Subject: 405 Essa Road application for a Zoning Ammendment and Draft Plan

RE: 405 Essa Rd application for Zoning By Law Amendment and Draft Plan of Subdivision

File: D12-436 / D14-1643 IMS:PSDC669 / PZOA842

RE: Application for Draft Plan of Subdivision and Zoning By-law Amendment Sean Mason Homes 405 Essa Road, City of Barrie

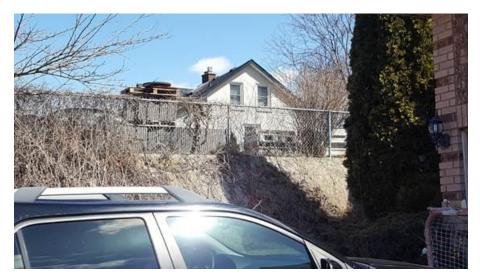
Attached is a picture of the single family home at 21 Cityview Circle that is beside Phase 3, along with the single family two storey home at 405 Essa Rd in the back ground.

The proposed 3 storey townhome will be 3 metres from this fenceline and 7 metres from the front door.

The proposed 3 storey townhouse will appear as a 4 story from Cityview Circle, due the elevation of 405 Essa Road, and will tower over the adjacent homes, starting 3 metres from the fence line and a 4 storey town home, will be adjacent to the back yard of 21 Cityview Circle, will appear as a 5 storey from the back yard due to the elevation.

Mr Mayor. As the above pictures demonstrate, this will not be an adequate transition to an existing single family neighborhood.

We are requesting that the Mayor, Council, and the Planning Department consider that this plan be changed from a 3 and 4 storey development to a 2 and 3 storey development to have an appropriate transition the existing neighborhood.
